780 BLANSHARD - REHABILITATION + ADDITION

HAV00034 CONCURRENT WITH REZ00825

Bubbled areas indicate revisions compared to the previously submitted plans

DATE	REV	ISSUE DESCRIPTION
2022-02-24	1	REZONING PRE-APPLICATION
2022-06-01	2	OPEN HOUSE PROGRESS SET
2022-06-21	3	REZONING APPLICATION
2023-03-23	4	HAP & REZONING RESUBMISSION

1 Axonometric View of Overlaid CBD-1 + DCAP Setback Envelopes (East)
A015

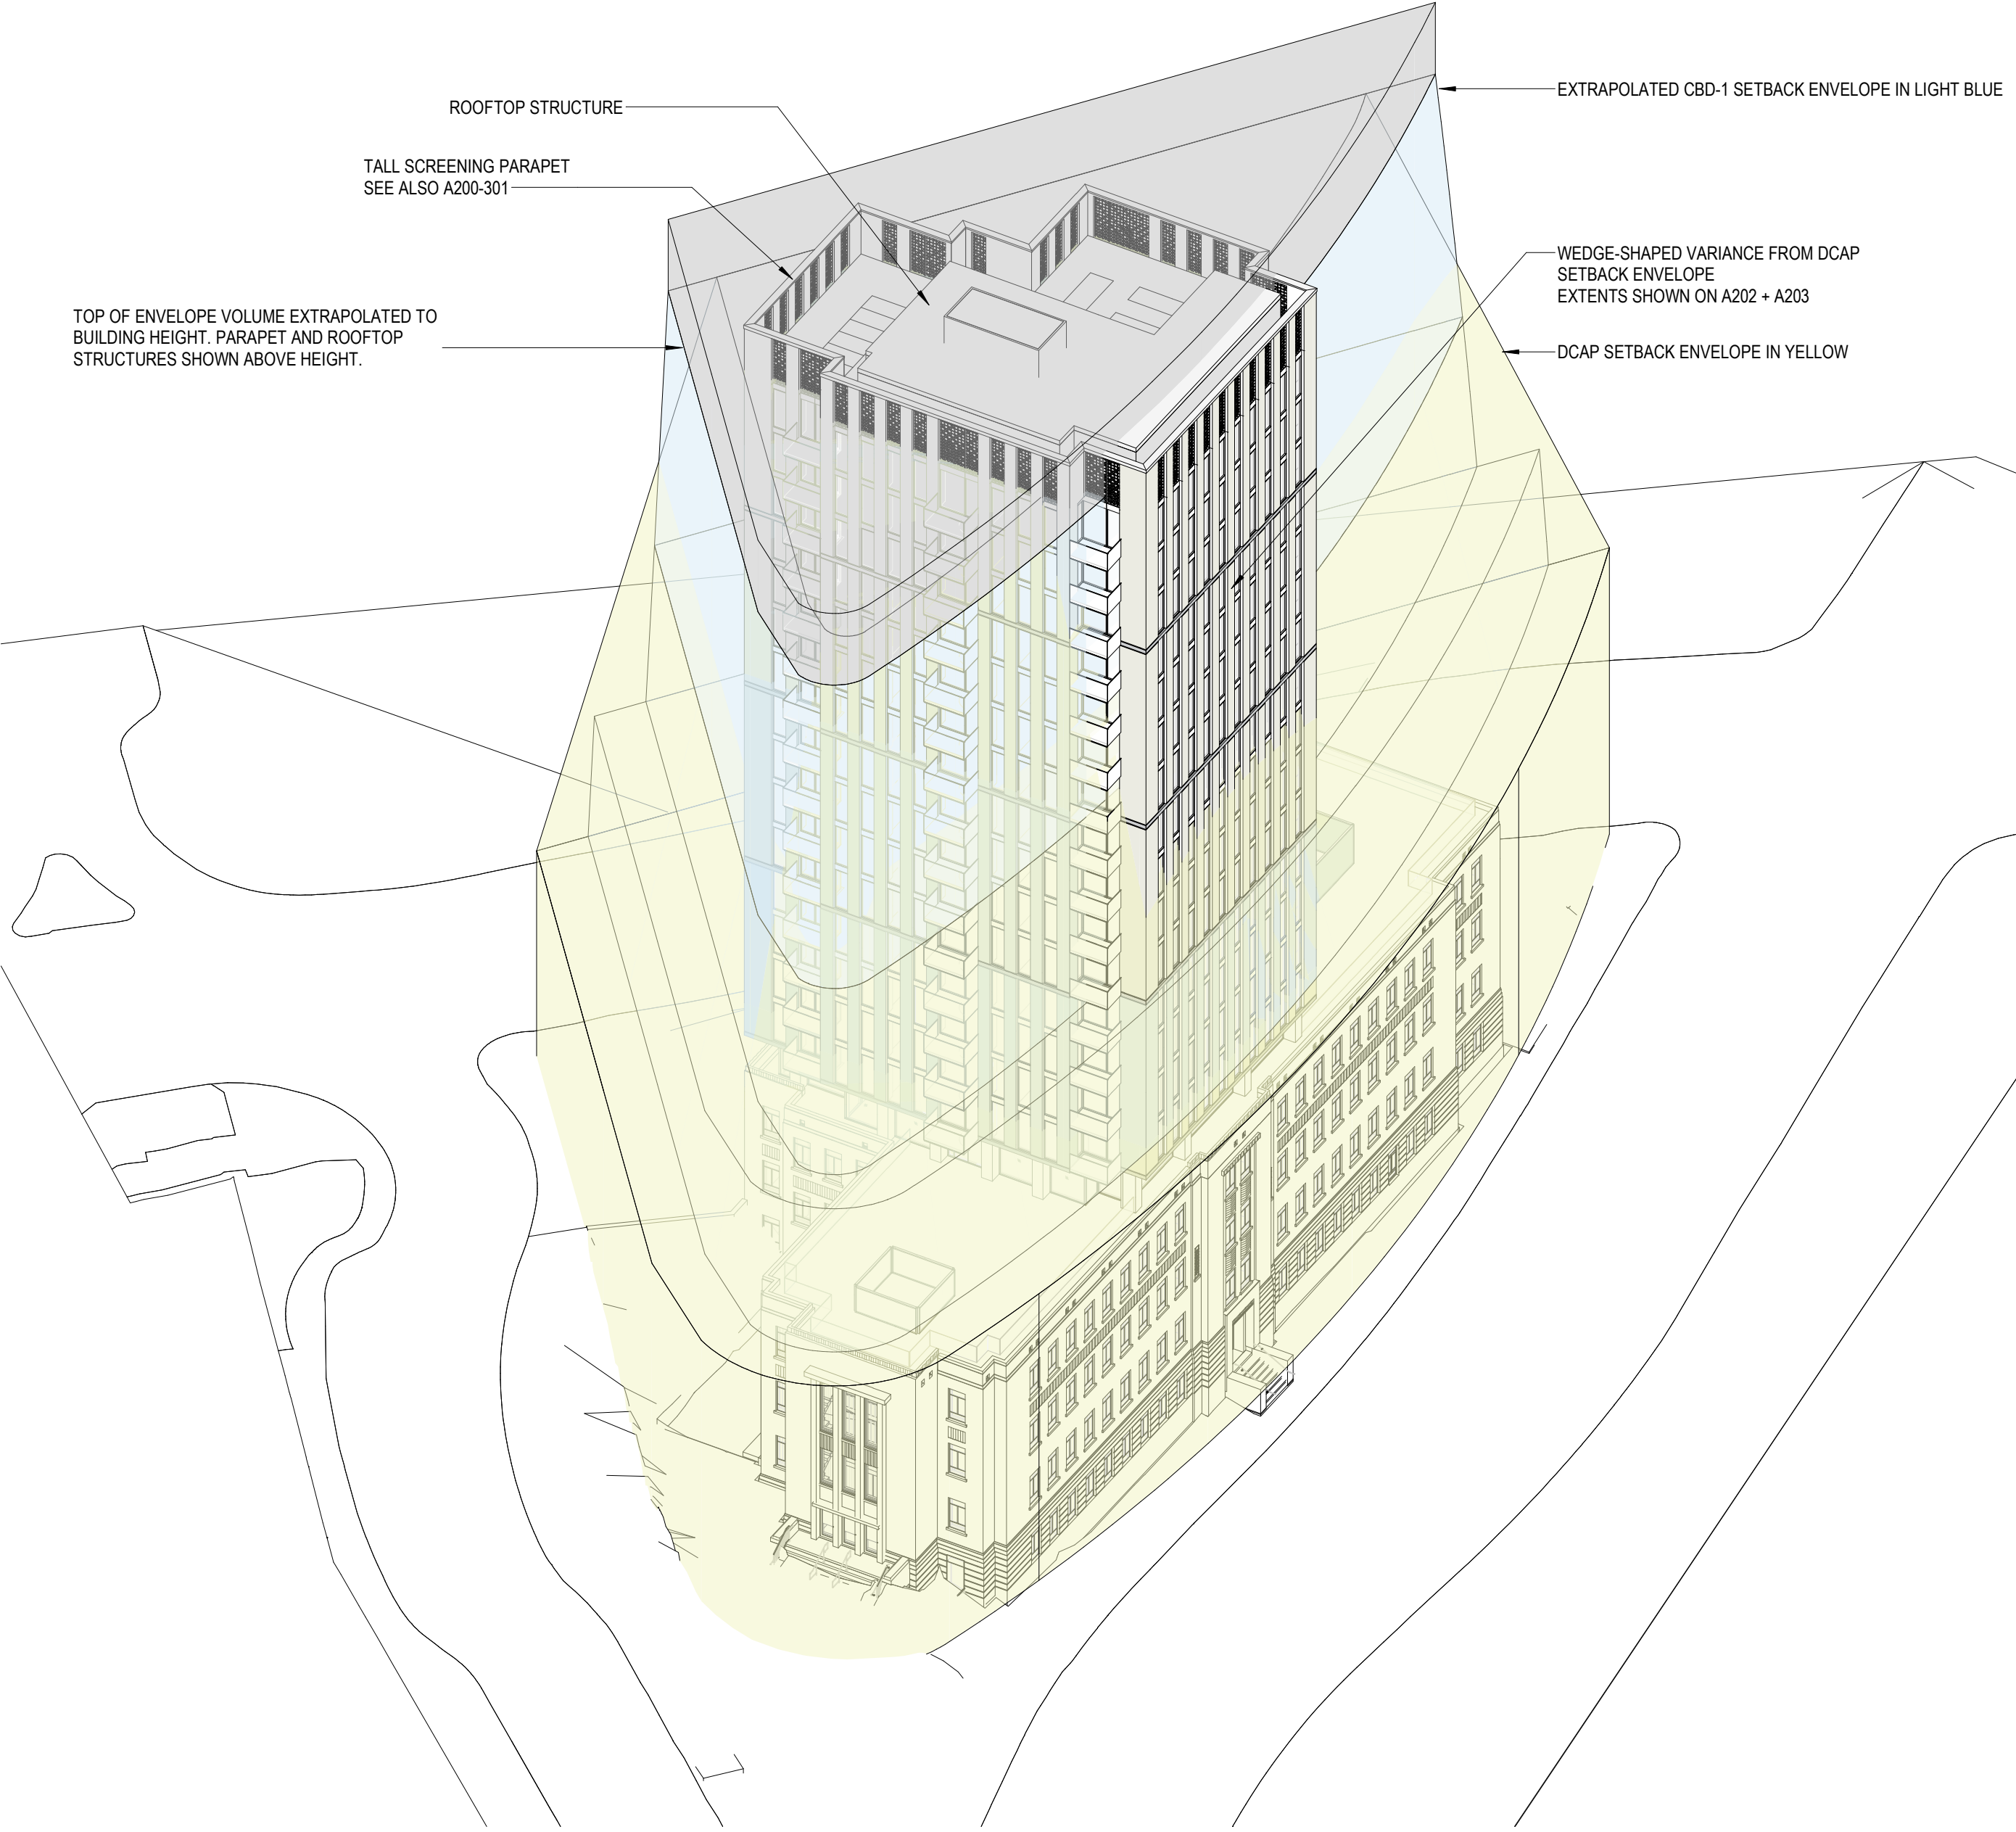
16 Zoning envelope diagrams updated with shorter revised massing developed in response to ARS Comment #22.
